# TECHNICAL EVALUATION REPORT

## EVALUATION OF SPENT FUEL RACKS STRUCTURAL ANALYSIS

NORTHEAST UTILITIES  
MILLSTONE NUCLEAR POWER STATION UNIT 2  
TER-C5506-586

December 17, 1985

Figure 4. CESHOCK Model of Millstone 2 Region II  
7 x 9 Spent Fuel Rack Module

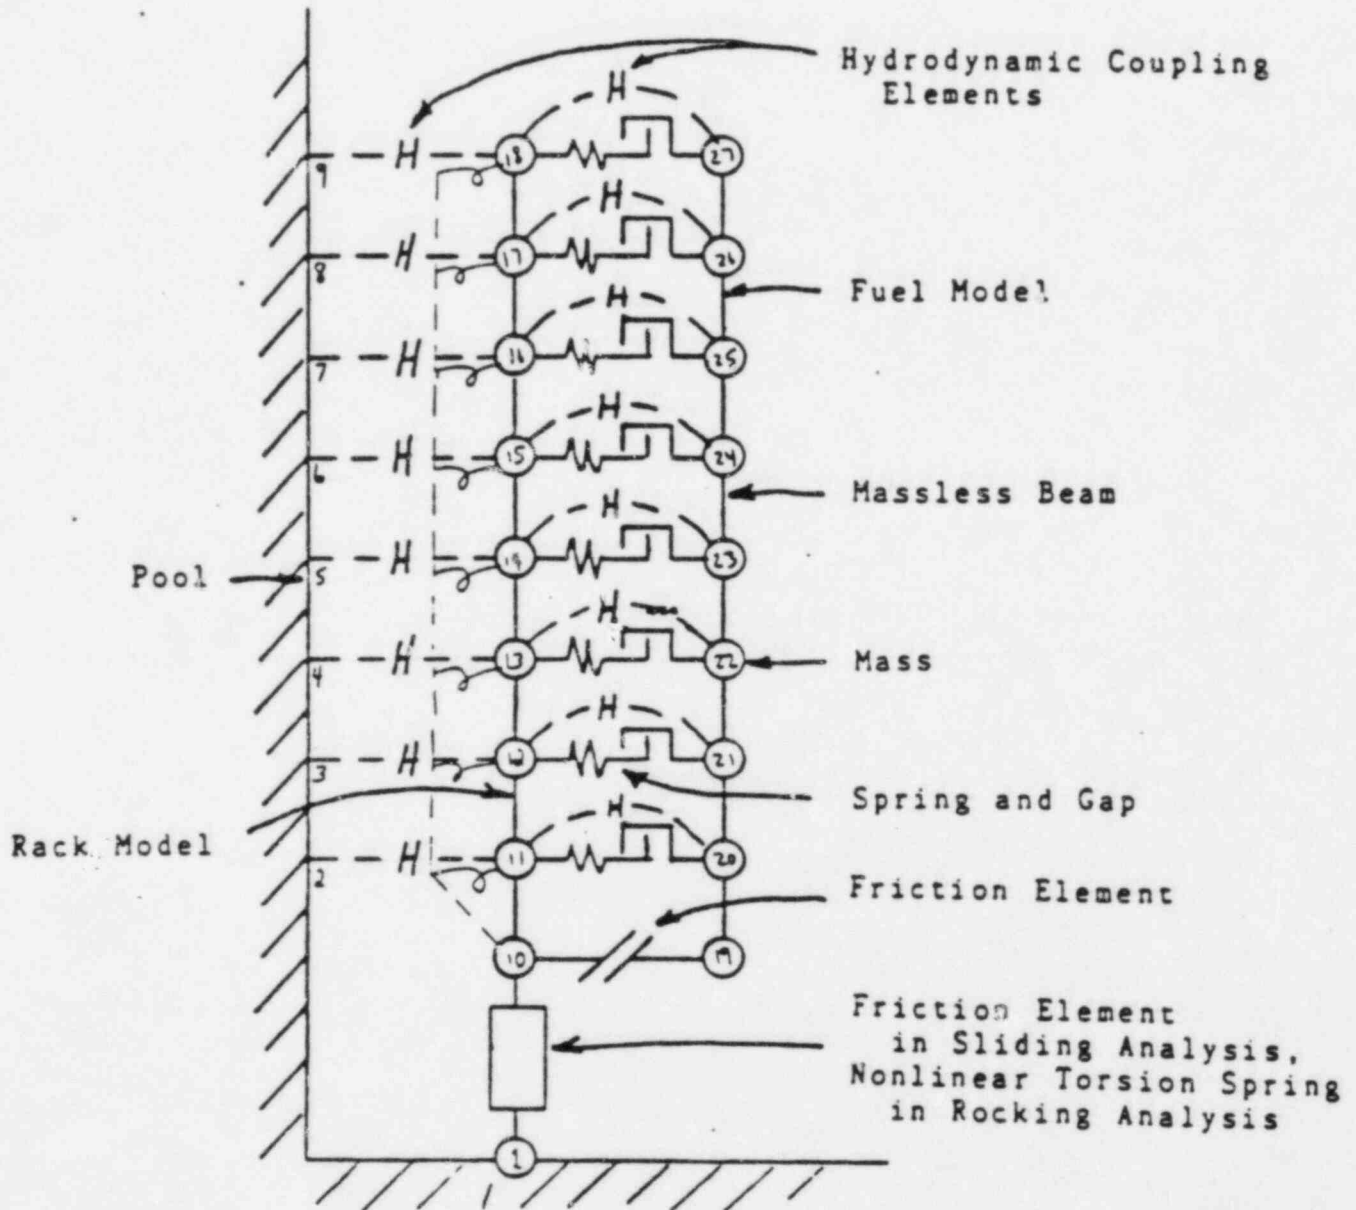
Hydrodynamic mass coupling of the rack module to adjacent rack modules and to the spent fuel pool walls is shown in Figure 4, and is discussed in Section 3.2.3.

Evaluation indicates that the Licensee's modeling of the spent fuel racks for dynamic analysis is acceptable.

Figure 5. Isometric Views and Key Diagrams

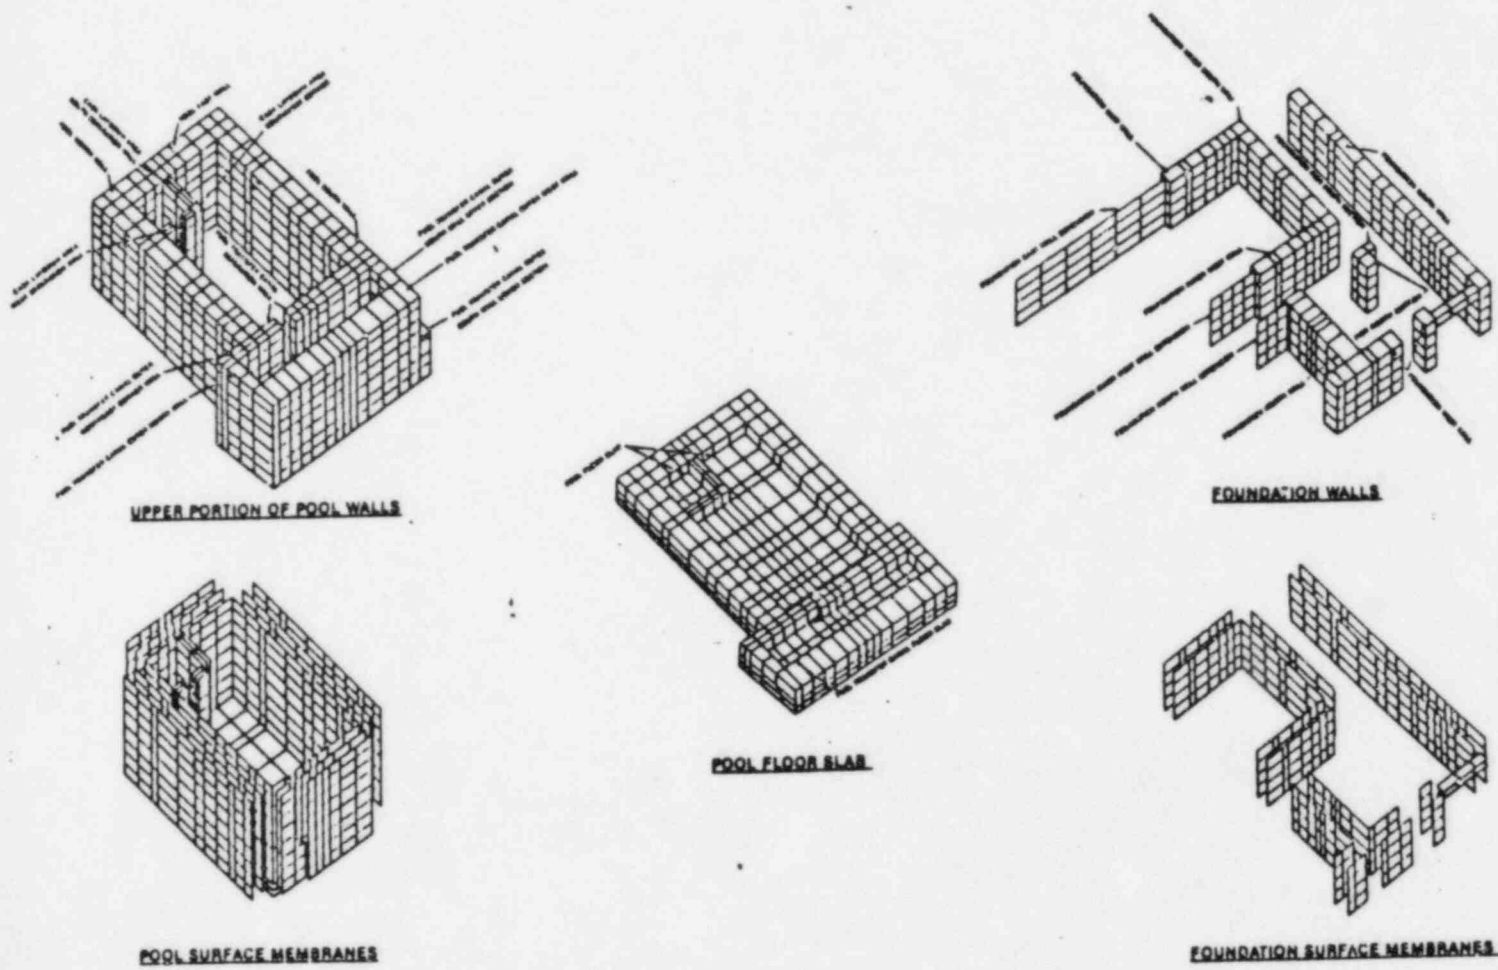
Evaluation of the Licensee's spent fuel pool analysis indicated that there is satisfactory design margin in the pool structure to accommodate the high density fuel assembly storage.
